Southern California Edison Company

Subject: Docket Nos. 50-361 and 50-362
San Onofre Nuclear Generating Station
Units 2 and 3

RESPONSES TO NRC QUESTIONS
SAN ONOFRE NUCLEAR GENERATING STATION
UNITS 2 & 3

<u>QUESTION</u>	<u>SUBJECT</u>
121.18 - 121.24	Reactor Vessel Materials Appendix "G" Compliance
121.26	Reactor Coolant Pump Flywheel Integrity
221.18 & 221.20	Core Protection Calculator
212.159	Loss of Component Cooling Water to Reactor Coolant Pumps
331.19 -	Spent Fuel Transfer Tube Shielding

Figure 121.21-1

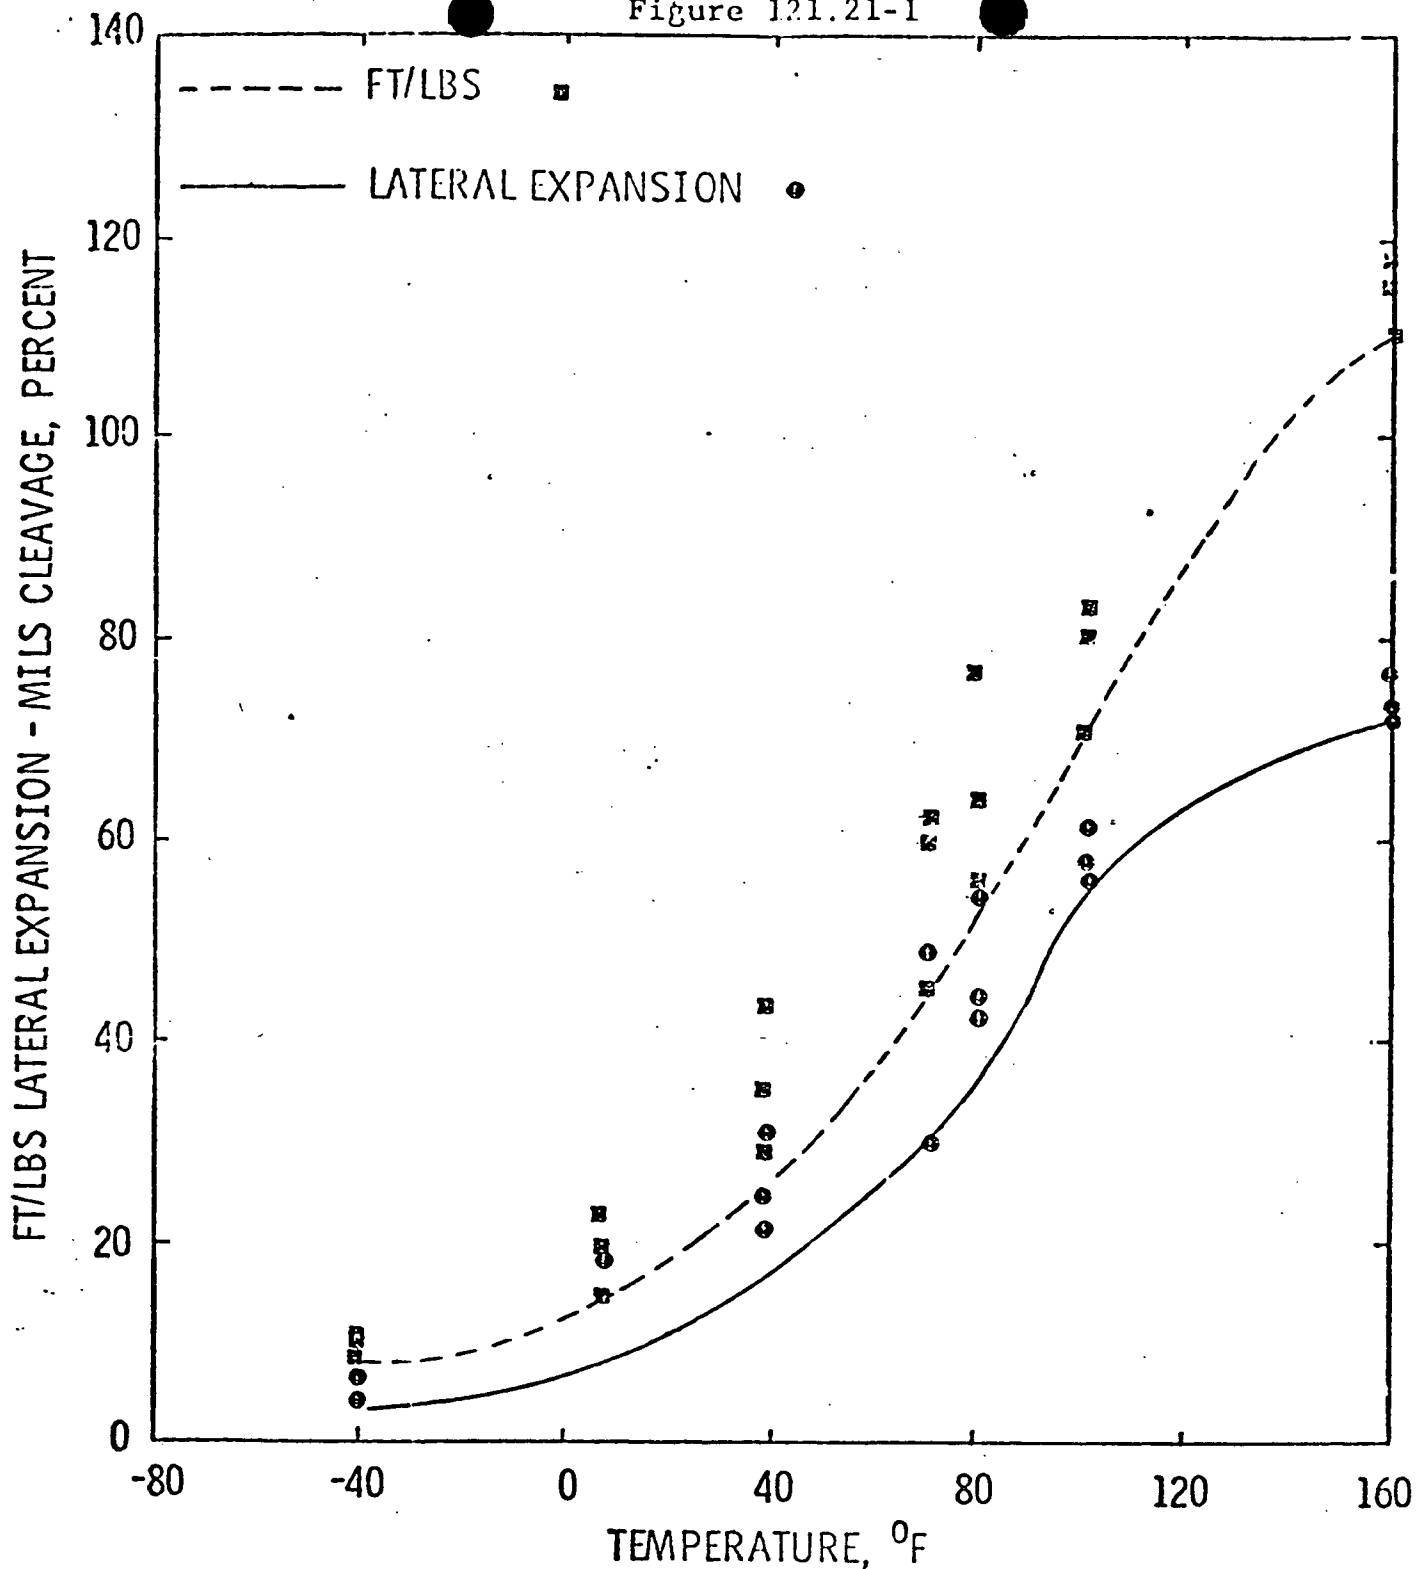
- (1) for the reactor vessel beltline materials, provide full Charpy V-notch curves, including data points, reported in impact energy and lateral expansion, both as a function of temperature;

- (1) Beltline materials Charpy test results for Units 2 and 3 are shown in Figures 121.21-1 through 121.21-12, respectively. The data points have been included. Tables 121.12-1 through 121.21-12 provide the data in tabular form corresponding to the Figures. The revised FSAR figures will be provided by 9/15/80 showing the Charpy test results.

FIG. 121.21-13 CHARPY V-NOTCH TEST RESULTS

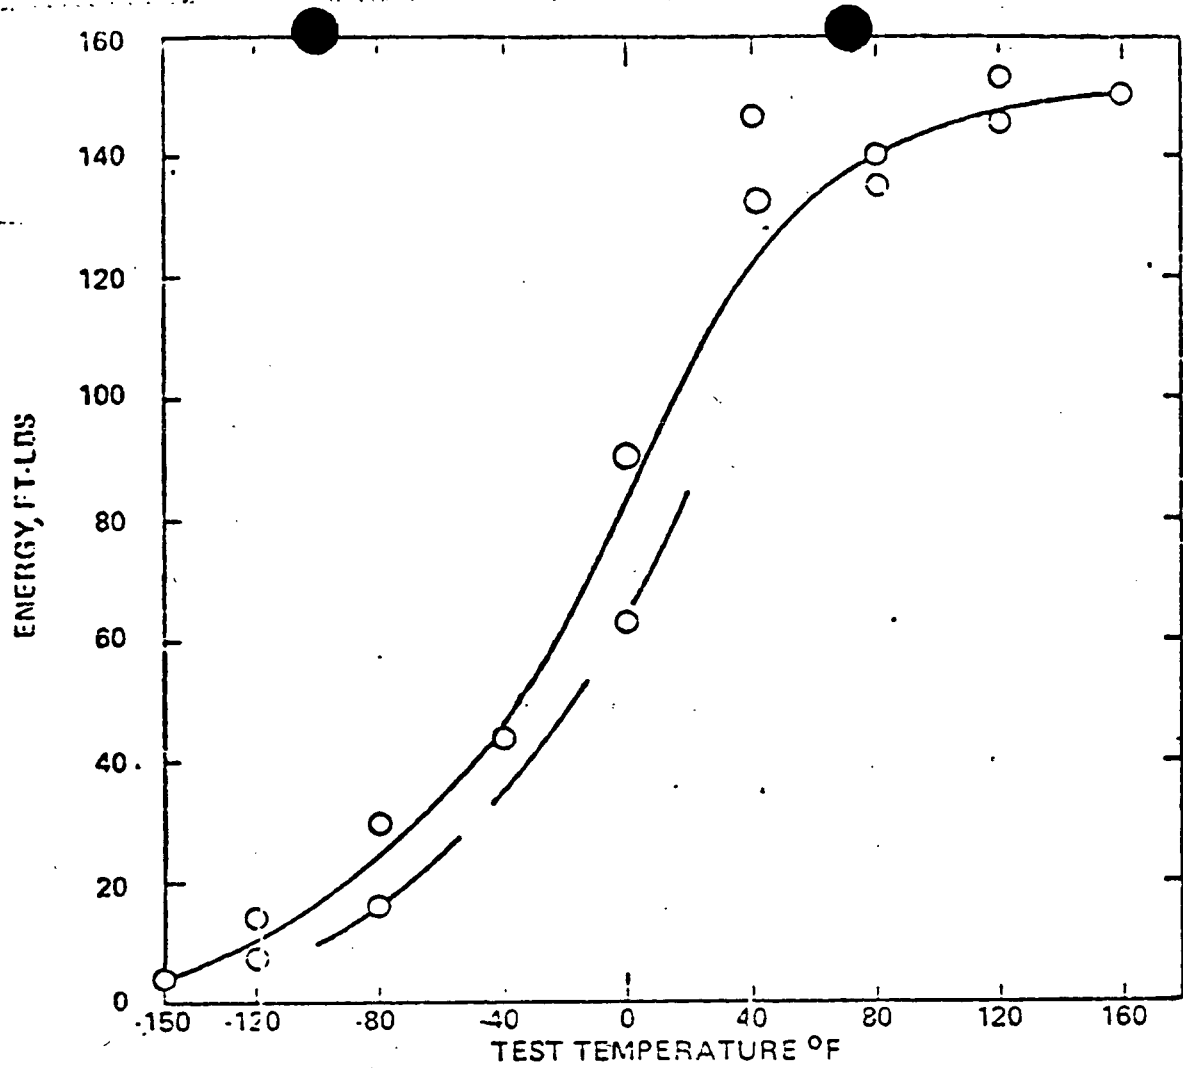
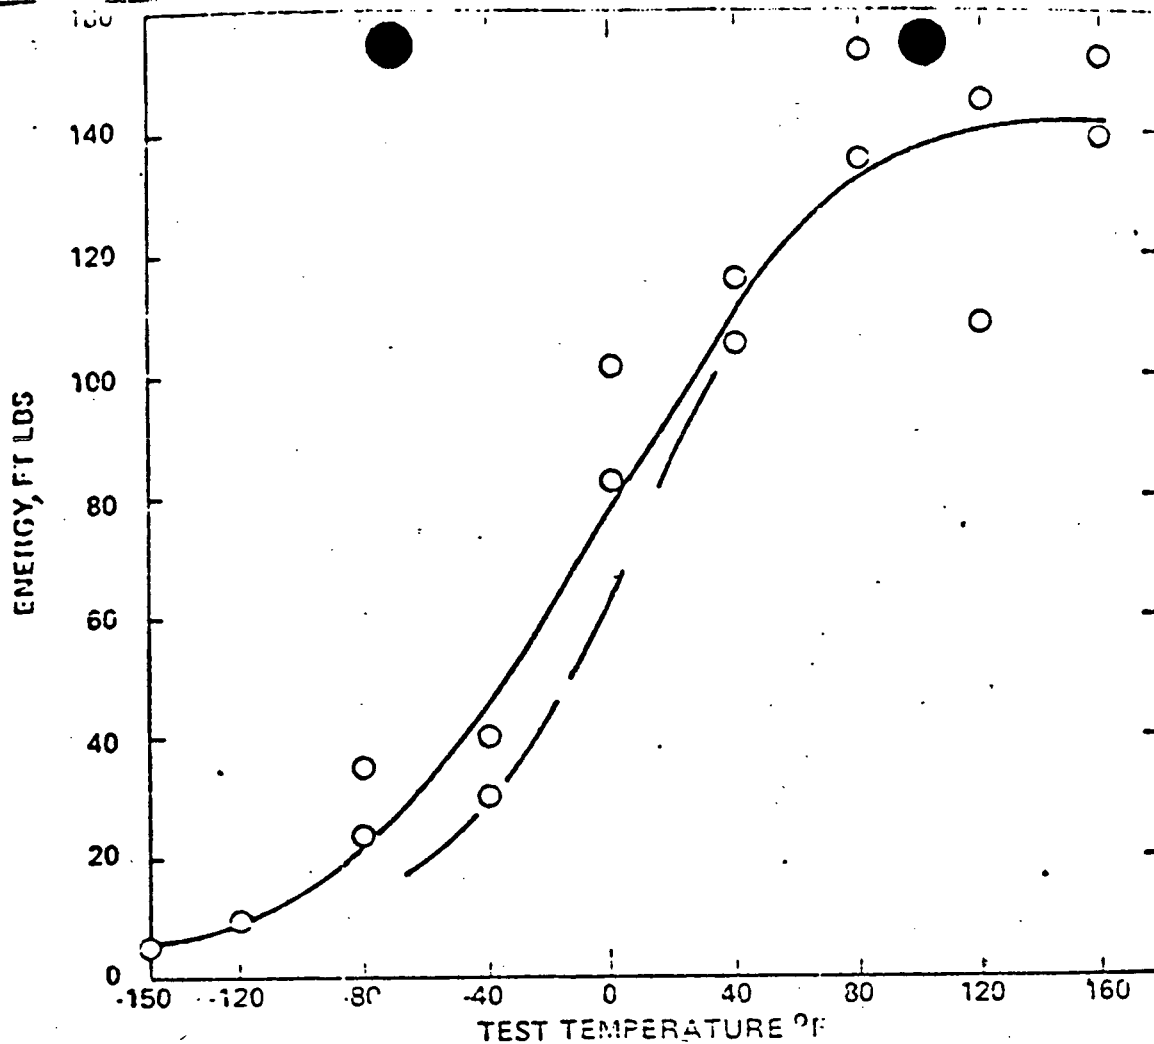
- (2) for welds and weld heat-affected-zones in the beltline region, provide fracture toughness data from either available data or additional tests. Include transition temperature data, upper shelf energy data, and the significant variables that affect fracture toughness properties, e.g., weld wire, flux, base metal combinations, and heat treatment. Correlate this information with data already presented in Tables 121.11-1 through 121.11-27, and provide analyses of the additional data to demonstrate compliance with all the fracture toughness requirements of Appendix G;

Attached Figures 121.21-13 and 14, and 121.21-15 and 16 provide additional Charpy V-notch test results for the weld and HAZ materials of San Onofre Units 2 and 3, respectively.

Figure 12.3-30

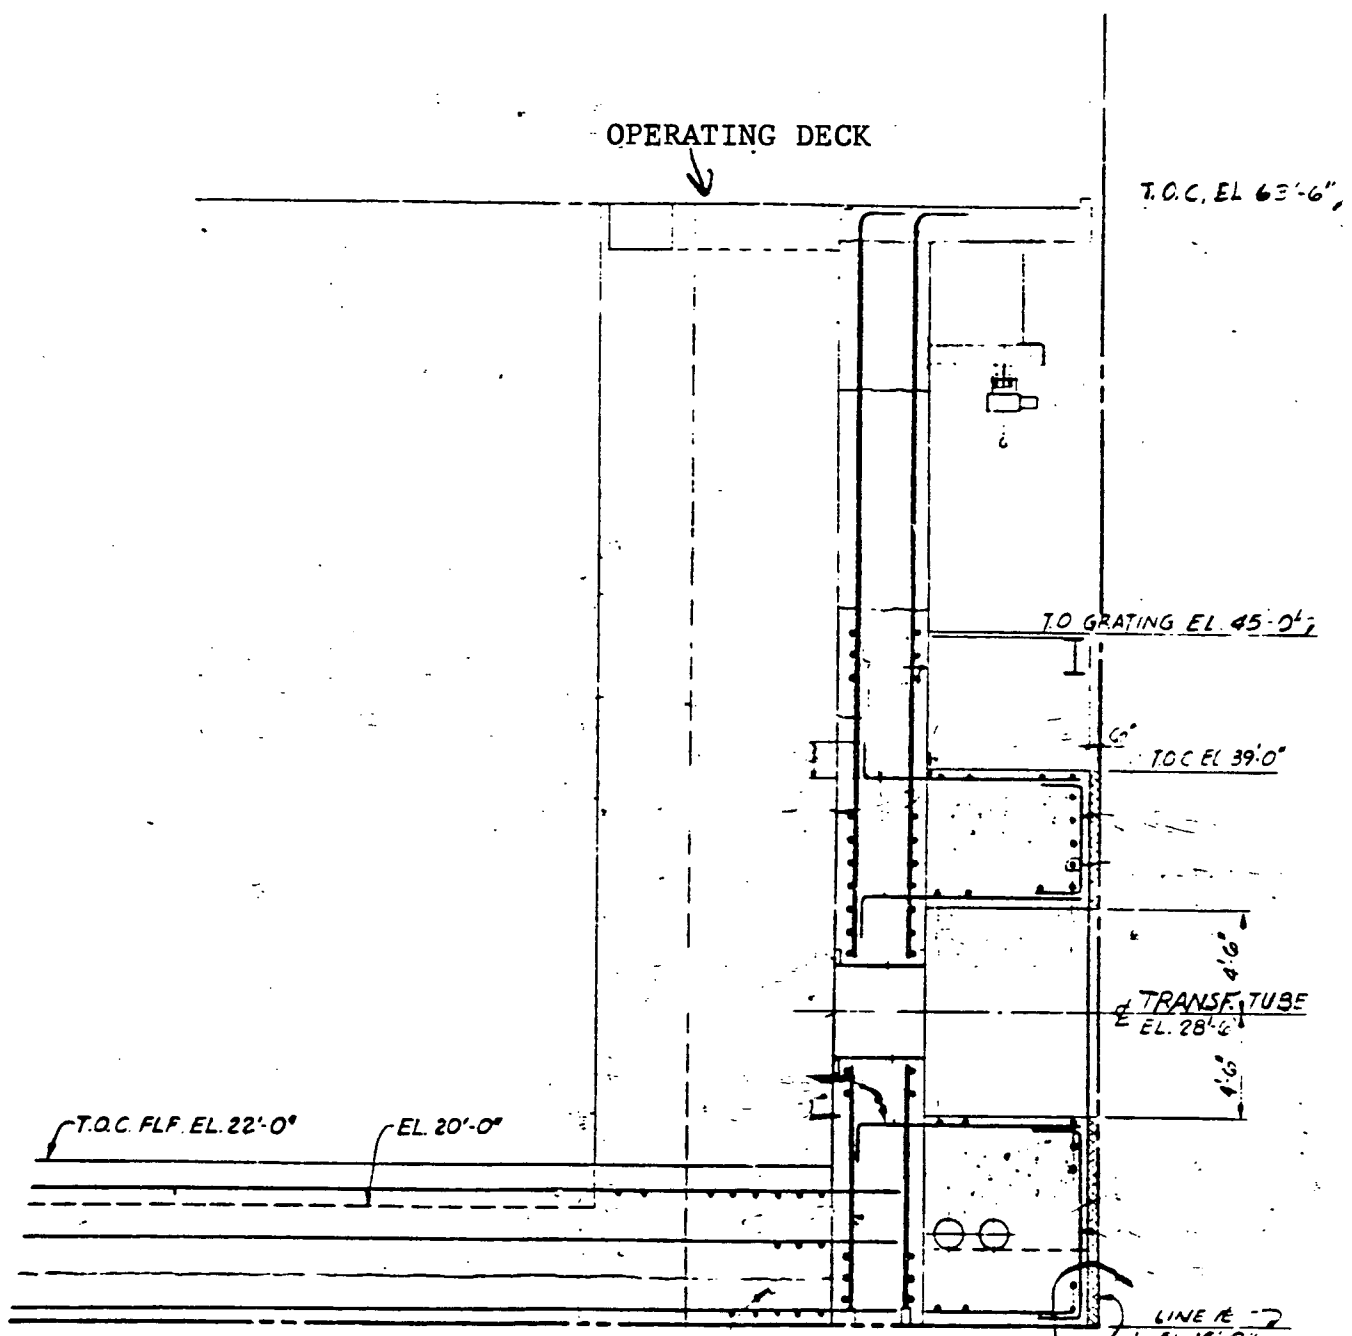
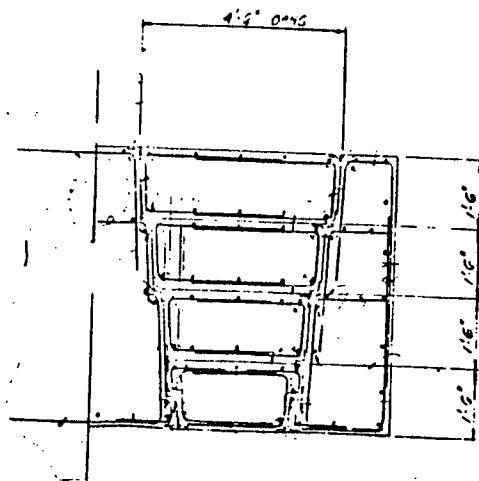
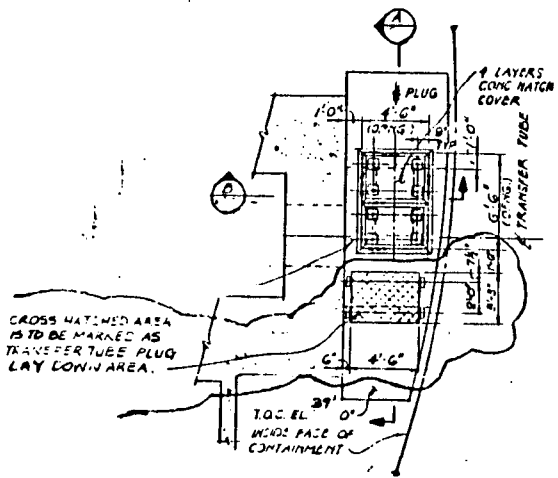
QUESTION 331.19

Inside containment 100 lbs/ft³ lead foam is used to fill the seismic gap between the containment wall and transfer tube concrete shield. Figures 12.3-30 and 12.3-31 show the fuel transfer tube shield design inside containment.

Six feet of concrete shielding is provided around the fuel transfer tube inside containment. To prevent radiation streaming, the six inch seismic gap between the containment wall and transfer tube concrete shield is filled with 100 lbs/ft³ lead foam. With this shield design the maximum dose rate from a single spent fuel assembly passing through the fuel transfer tube, assuming three days decay, will be less than 5 mrem/hr. To provide access to the fuel transfer tube for local leakage rate tests, concrete hatches are provided above the transfer tube. Figures 12.3-30 and 12.3-31 show the fuel transfer tube shield design inside containment.
